South Whidbey Aquatic Center

Addendum # 3

June 20, 2025

To All Bidders: Attention is called to the following items effective June 20, 2025, which shall be added to, deleted from, or changed from the BID DOCUMENTS dated June 2, 2025, thereby incorporating the addendum as part of the CONTRACT DOCUMENTS.

3 DOWNSPOUT @ PANEL SIDING
3" = 1'-0"

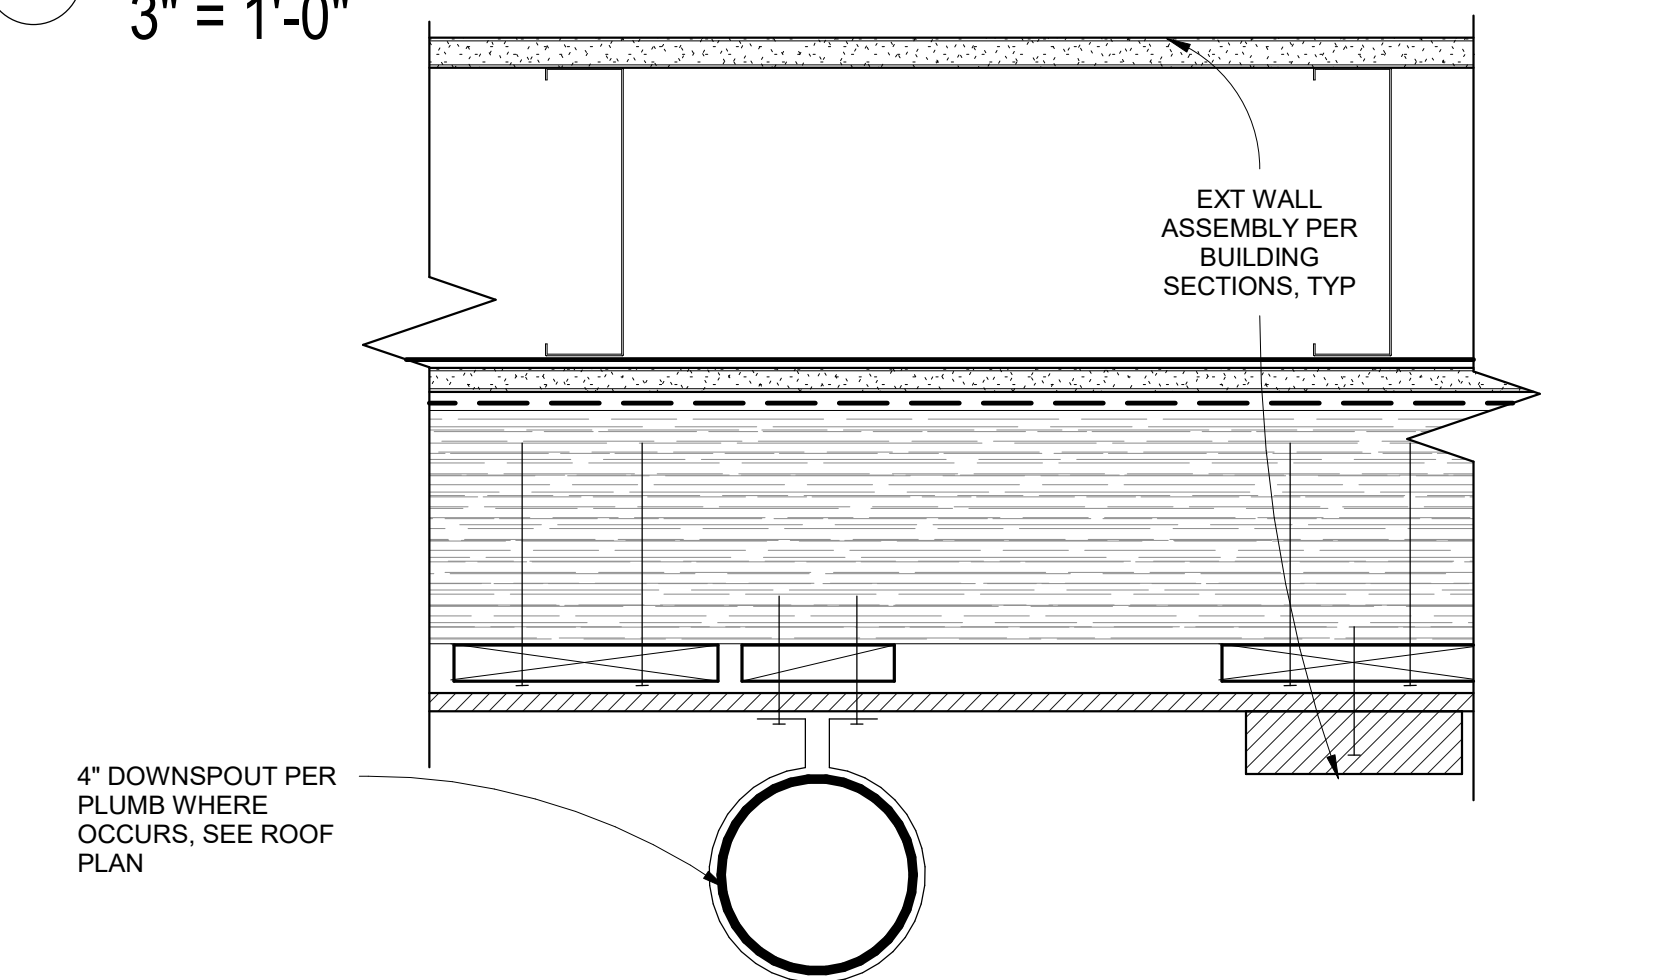
- iv. **REPLACE** – Sheet A8.5 in its entirety with the attached revised sheet A8.5.
 - 1. Updates to details 1, 2, and 5.
